AR Jeans Producer Ltd.

20th March 2018

Observations

5th floor load plan

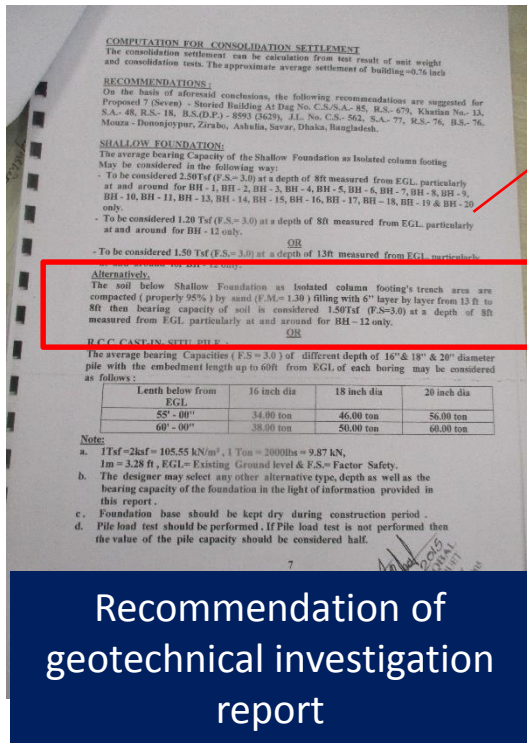
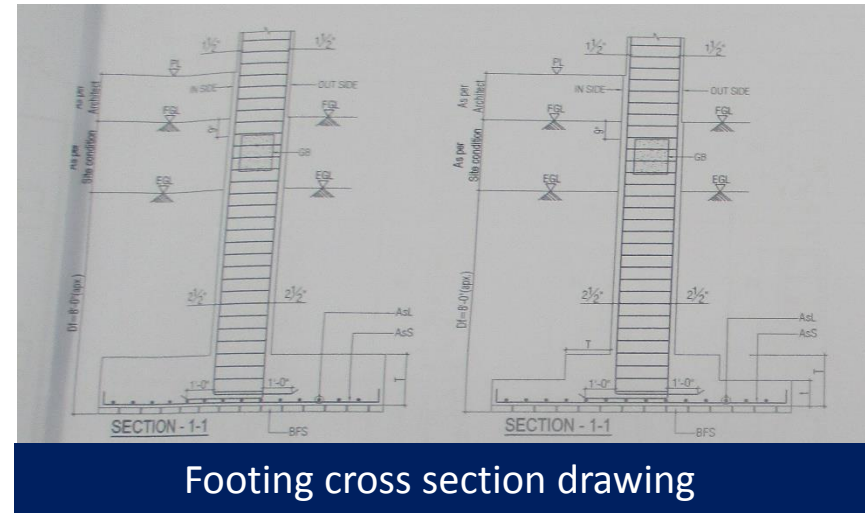
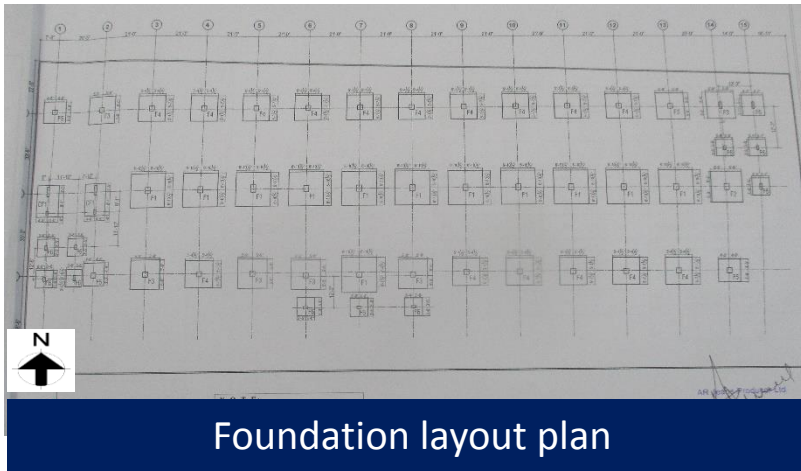
Cursory calculations indicate that few Columns under toilet area & water tank would appear to be stressed in excess of normal design limits, assuming minimum concrete strength. Building Engineer to review design, loads and columns stresses. Also, prepared load plan need to be revised based on floor, column and foundation capacity.

P.C.C CAST IN SITU PILE

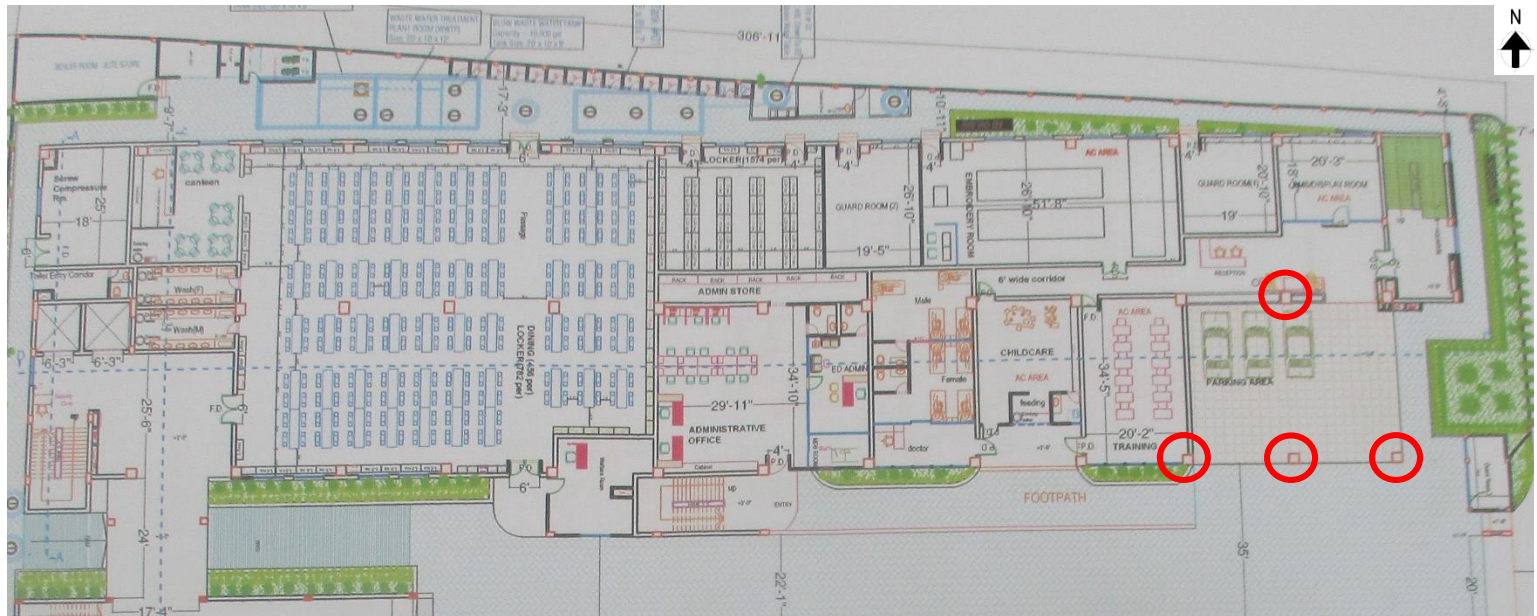
Cursory calculation indicates that footing appears to be stressed above normal design limits. Factor of safety (FoS) is less than the minimum requirement BNBC. Factory engineer is required to review the adequacy of footings considering actual depth and bearing capacity of footing and comply with BNBC.

Ground floor layout plan

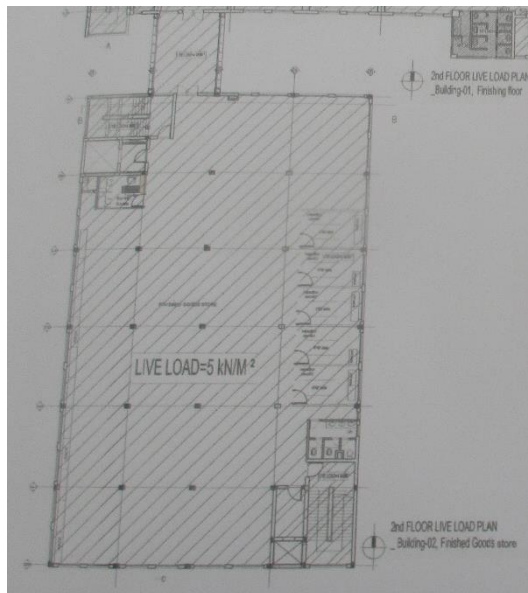
Impact protection not provided to columns at loading –unloading area. Columns are susceptible to impact loading from vehicles.

Load Plan of 2nd floor

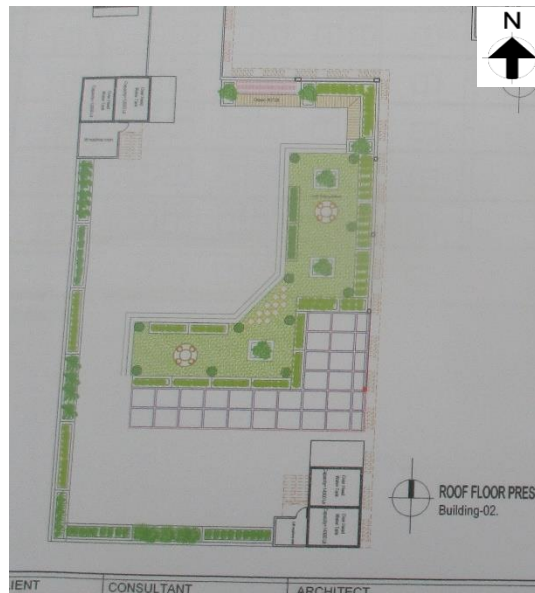
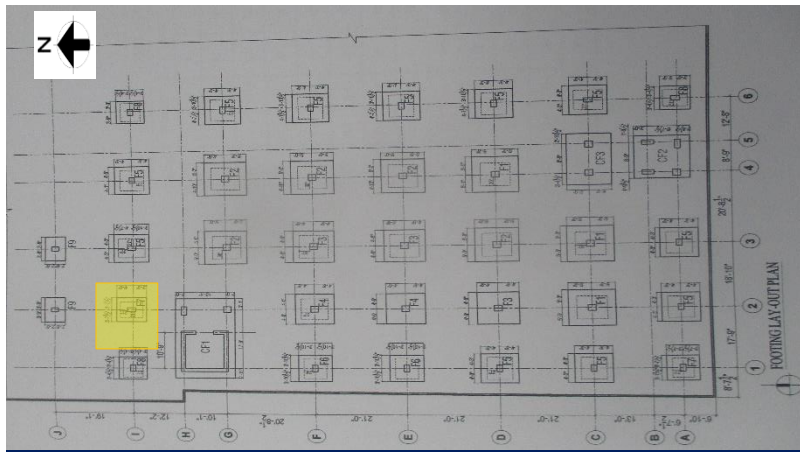
Factory engineer has prepared a floor load plan considering 5kpa live load. Cursory calculations indicates that columns appears to be stressed above normal design limit based on 3 kpa live load. So, prepared load plan need to be revised based on floor, column and foundation capacity.

Foundation layout plan

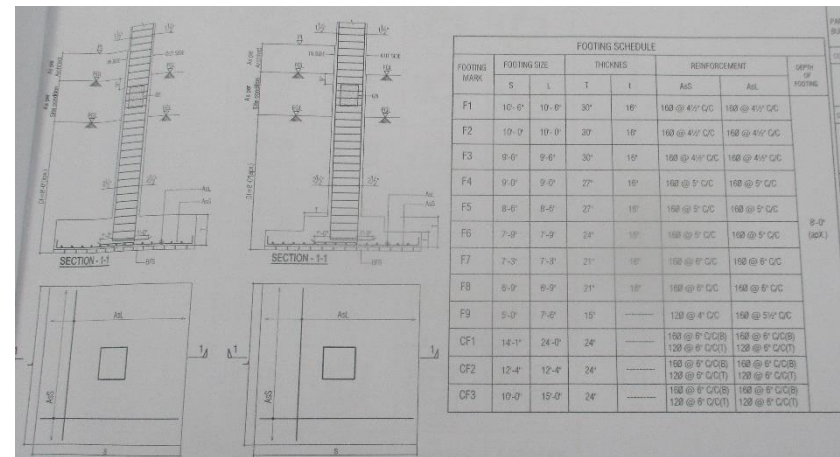
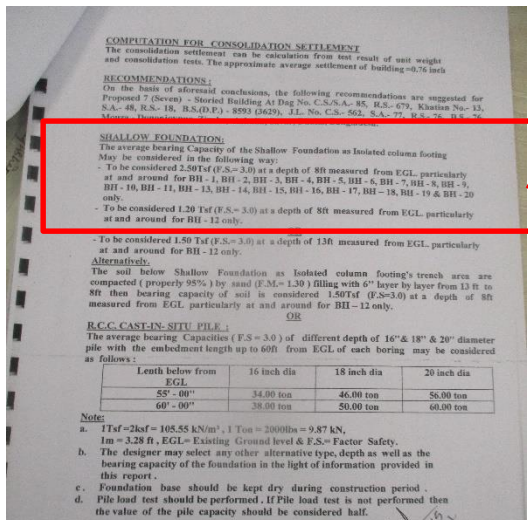
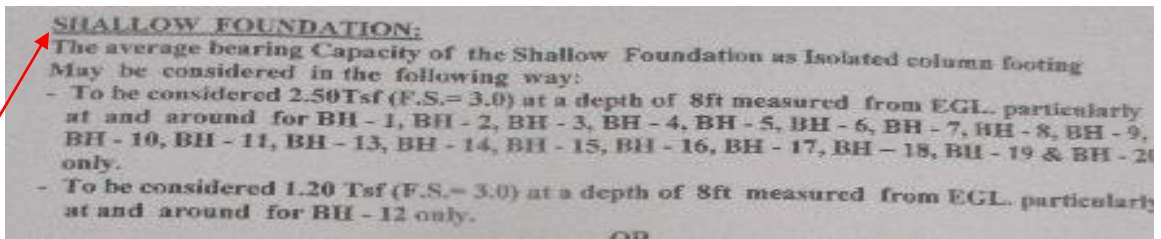
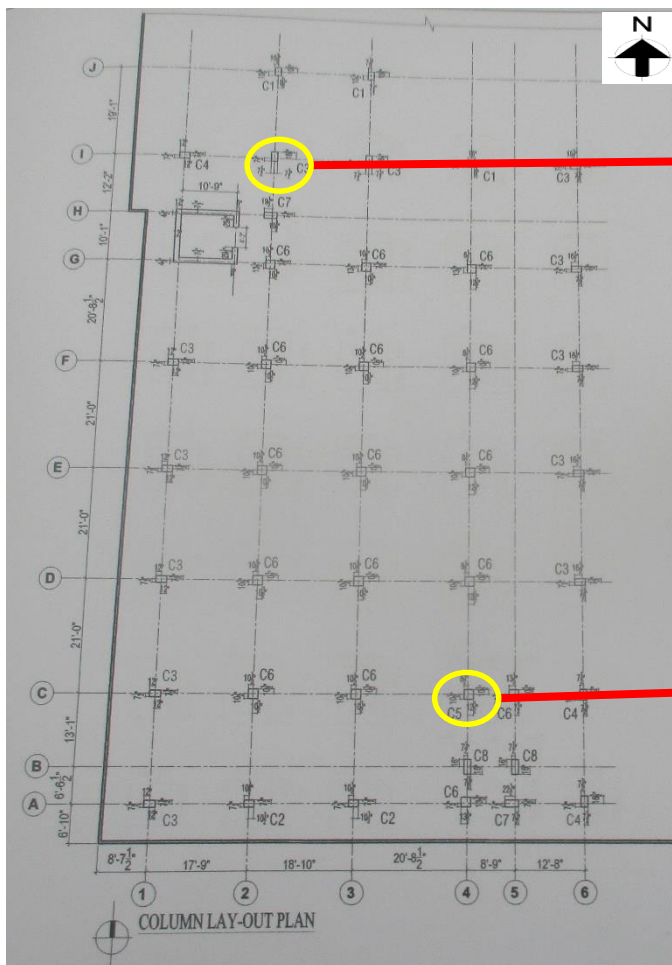
Cursory calculation indicates that footing appears to be stressed above normal design limits. Factor of safety (FoS) is less than the minimum requirement BNBC. Factory engineer is required to review the adequacy of footings considering actual depth and bearing capacity of footing and comply with BNBC.

Boiler Building

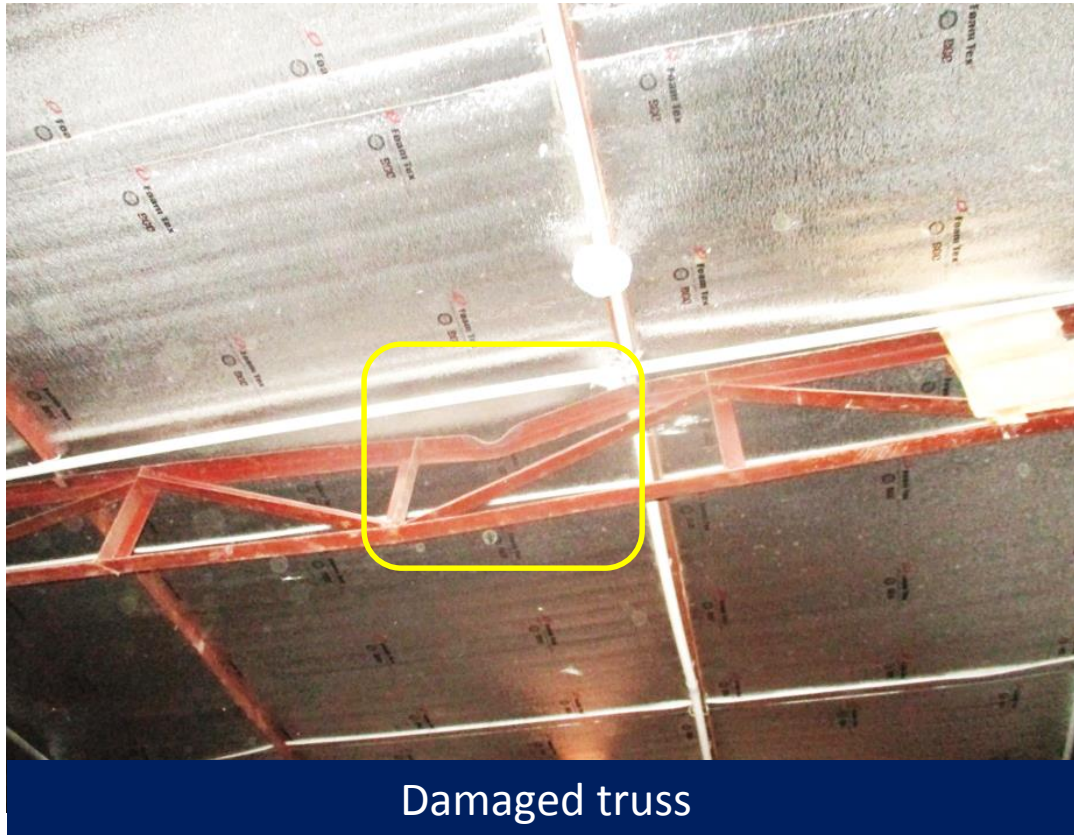
Architectural drawings are not prepared for all utility structures. Also mismatch found in provided structural drawings for generator, sub-station and boiler buildings. Number of rebar in column for generator & sub-station building do not match with column schedule. And grid dimensions are not matched for boiler building.
